Subject: RE: LU/411/21/PL 90-91 South Terrace, Littlehampton

However having discussed this matter with my client, who is keen for this project to progress, I attach drawings which show the render omitted and full height brickwork shown as per the previously approved plans and in accordance with the conservation officers requirements.

Photograph showing the adjacent terrace with a render finish to the 1st floor

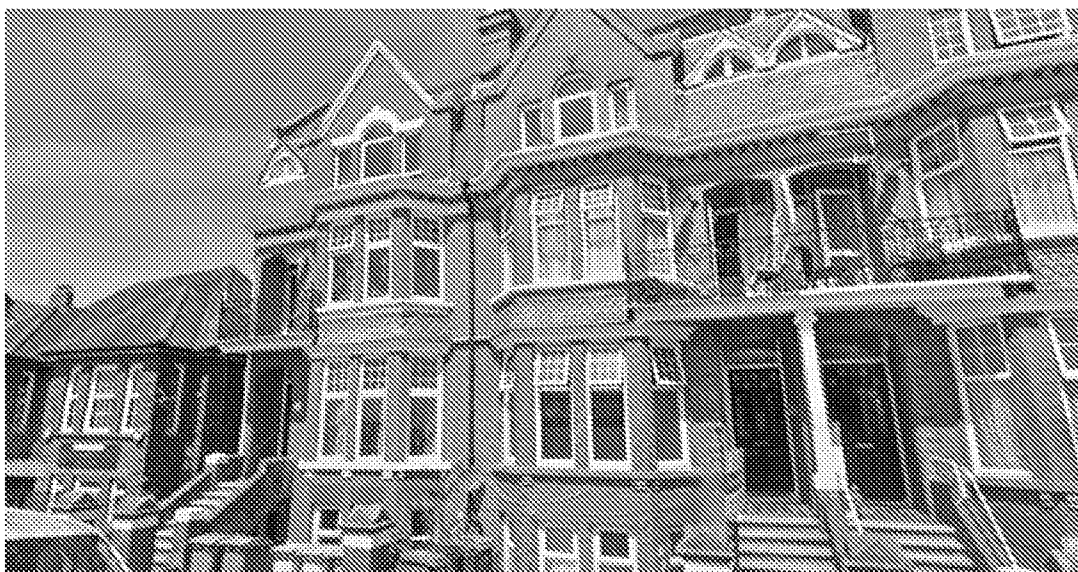
We note your grounds for objection for our proposal, in respect of the materiality proposed.

Render to the first floor (to match that of the neighbouring terrace) was chosen as my client, the contractor felt it would difficult to match the new brickwork above the existing given the existing is 100 years old and weathered accordingly. We felt the join between old and new could appear obvious and detract from the finished aesthetic and details such as the creasing tile headers over windows would be difficult to recreate using modern construction techniques. Use of a sand/ rough render finish at this storey height would match with the same storey finish on the terrace to the east of the proposal, so is not out of keeping with the adjacent street scene

Another reason for utilising render on this new additional storey is the construction to the new upper floors is to be lightweight construction to assist in reducing load on the existing structure, a render finish would enable a lightweight supporting structure to reduce weight. The use of a render would acknowledge the fact this is an evolution of the building. The render would only be to the 1st floor so would be at the same storey as the render on the 1st floor of the adjacent terrace (see photo below).

The use of slate roofing was proposed to lessen the loadings on the structure but, I'm inclined to agree with your comments that this perhaps a departure too far from the adjacent material finish, and so the reinstatement of a clay tile finish may be more appropriate and would better justify the brick lower storey, render upper storey, clay tile roof scape that can be seen on the neighbouring terrace.

Also shown are clay roof tiles, again in accordance with the approved plans and conservation officers comments.
